Assessment of Burnaby's Central Valley Greenway

The Burnaby Local Committee of HUB Cycling conducted an assessment ride of Burnaby's section of the Central Valley Greenway (CVG) on Saturday, 10 August 2024.

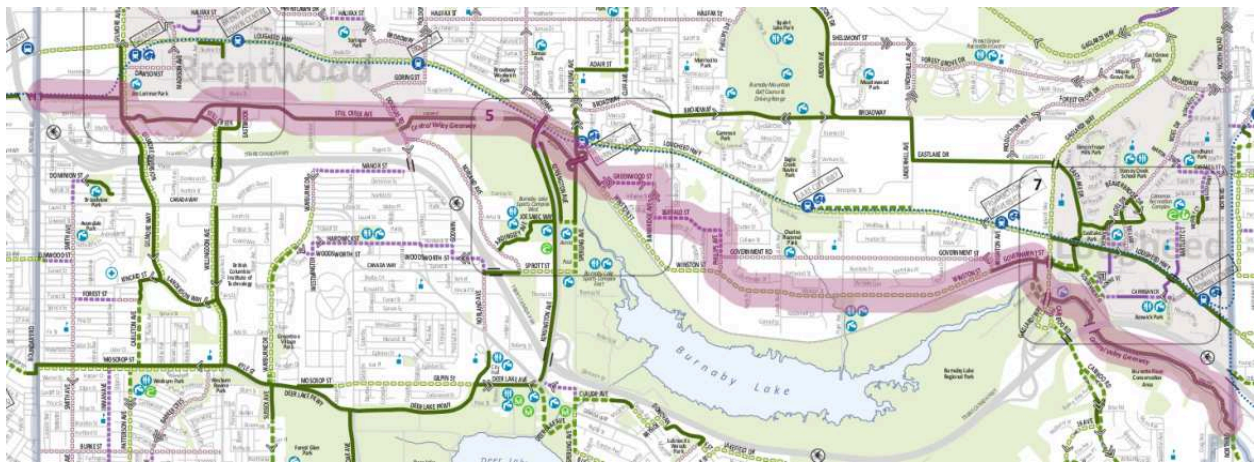
The CVG is generally in decent condition. However, the Winston St. detour and construction zone, which will remain in place for the foreseeable future, are not suitable for all ages and abilities. This has eliminated the accessibility of the CVG as an AAA bike route for the past few years. The current construction zone involves sharing the road on Winston St along single lane alternating traffic (figure 1), which is very uncomfortable for all but the most confident people cycling. For future major construction projects that result in closure or detour of bike routes, the detour options should be the equivalent level of comfort as the bike route that is impacted. For Winston St., this could have involved, placing quick-build concrete curbs along Lougheed Hwy and Brighton St. to form a safe and comfortable detour option.

Figure 1: Sharing the lane on Winston St. Left: Single-lane alternating traffic along Winston St. This works for people driving, but is extremely uncomfortable for people cycling and potentially dangerous if followed by a person driving aggressively. Right: The construction site on Winston St. unnecessarily takes away all road space for people riding bikes and forces them to share a narrow lane with vehicles.
